RE: **Memorial Park Anderson Heights Unit 4**
Engineer's Stamp Date: 1/22/2018
Hydrology File: N08D006F1

Based on the information provided in the submittal received on 1/22/2018 the above-referenced Grading and Drainage Plan cannot be approved for Grading Permit until the following comments are addressed.

MEMORIAL PARK
OVERALL GRADING & DRAINAGE PLAN

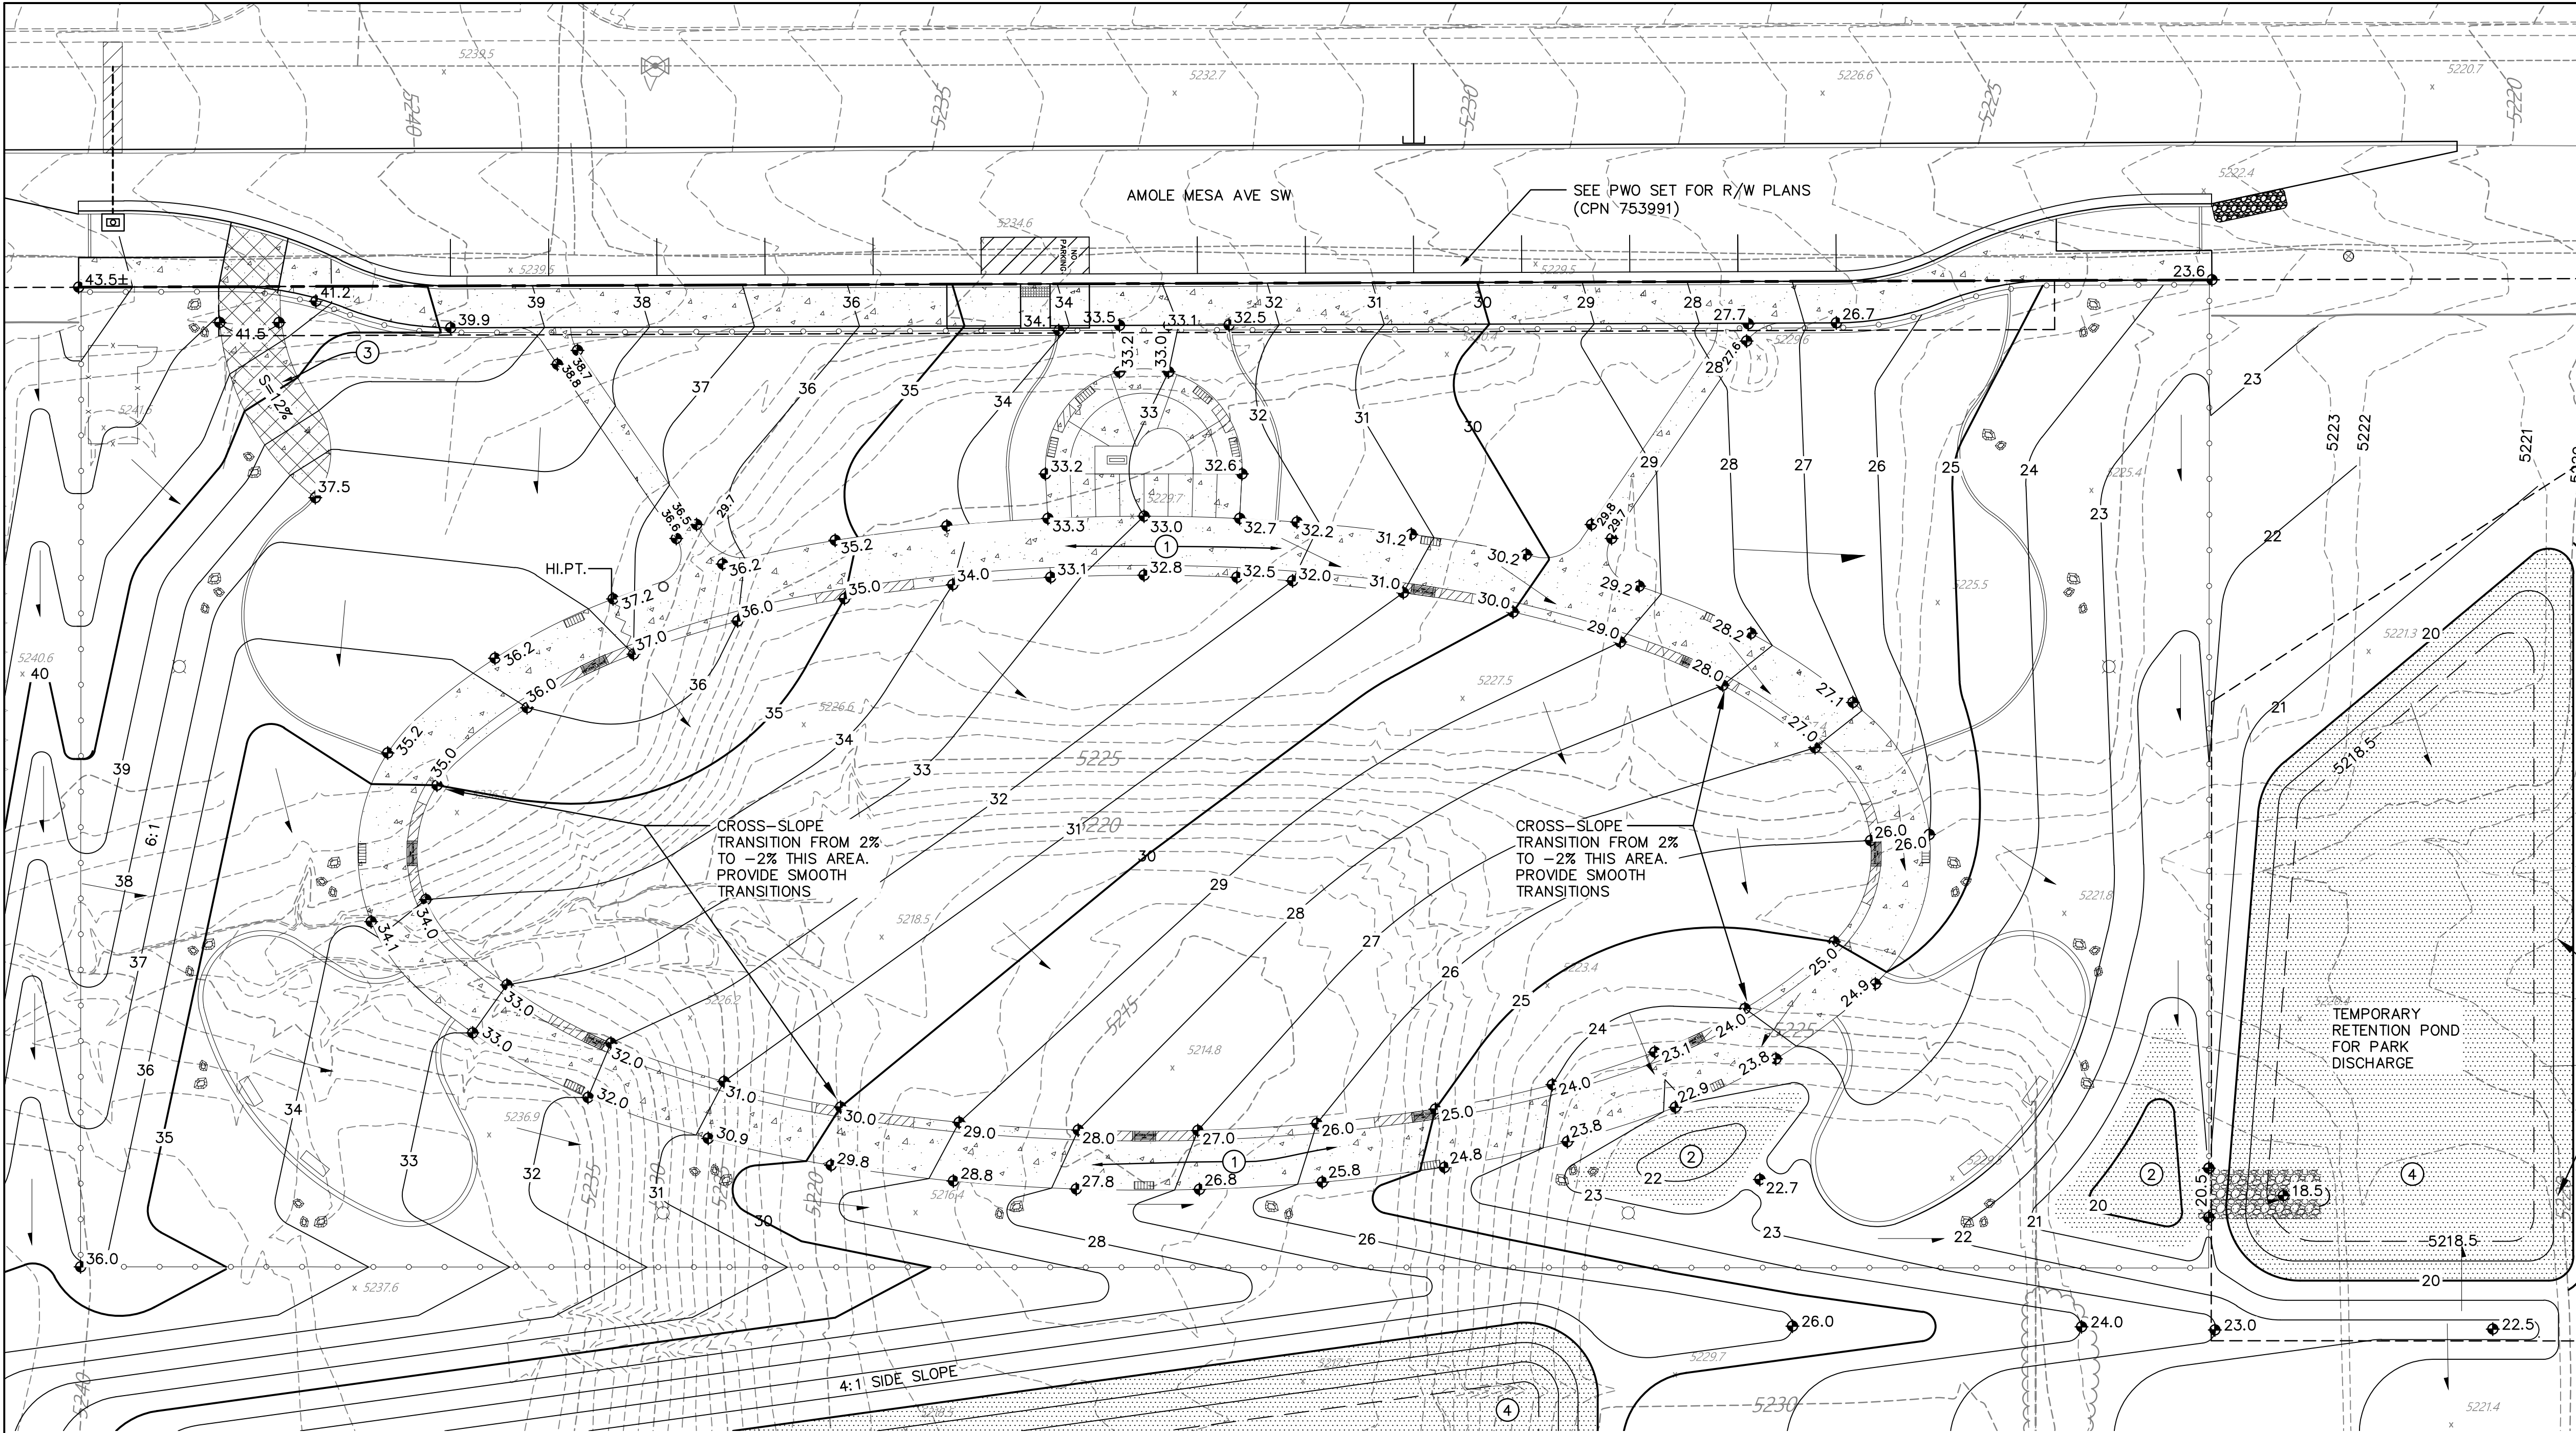
1. A Public Drainage Easement must be recorded to contain the east temporary retention pond.
2. A new Drainage Covenant must be recorded for the new pond location. The previous covenant can be released if the new covenant includes all of the ponds shown on the previous covenant.
3. Provide a letter of permission from the owner of the neighboring property for the grading on their property.
